Re: Significant Corrective Action Permit Application
230 Ridgefield Road, Wilton, CT

Following comments received at the Wetland Commission's June 10, 2021 meeting, the following responses are provided.

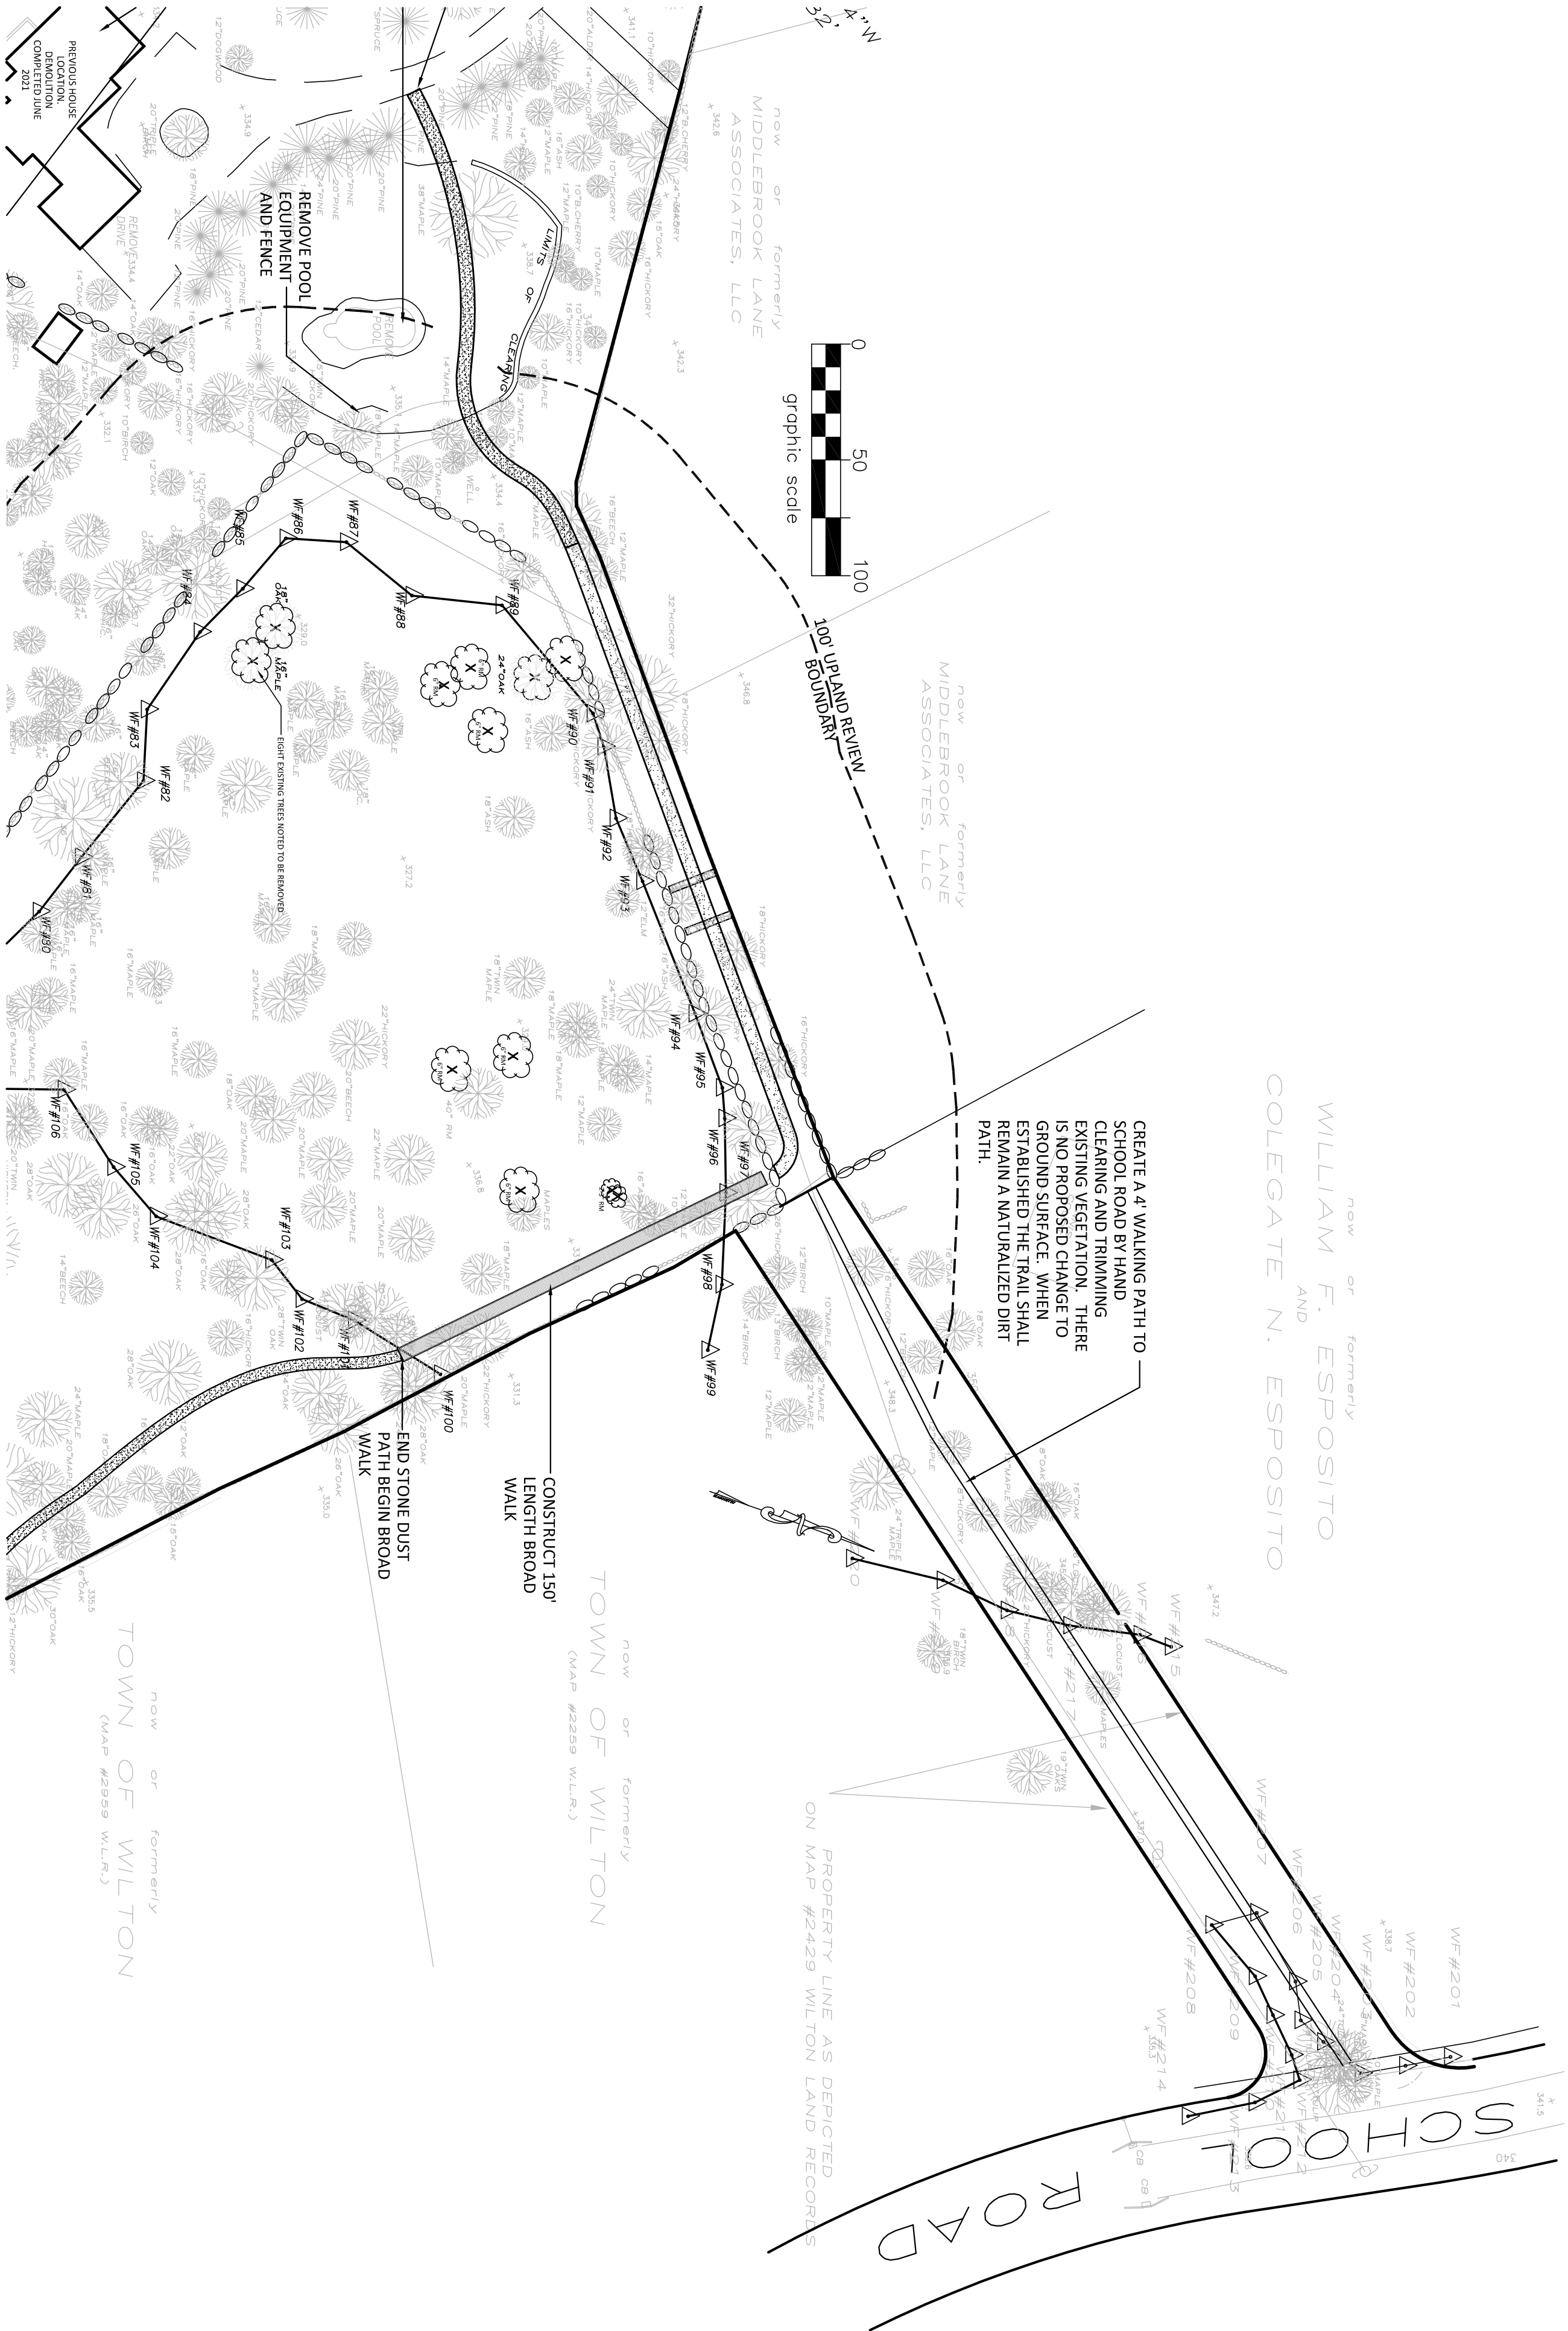
6. The staff asked that we clarify the establishment of a 4' wide foot path to School Road. A note has been expanded to the plans to clarify that this pathway will only involve branch trimming to allow a person to walk through an opening in the vegetation. There will be no change to the ground surface to create this path. Please refer to sheet WP-3.

REVISIONS:		DRAWING TITLE:
		ACCESS TO MIDDLEBROOK ROAD
1	6-22-21	ADD NOTE FOR FOOT PATH CONSTRUCTION
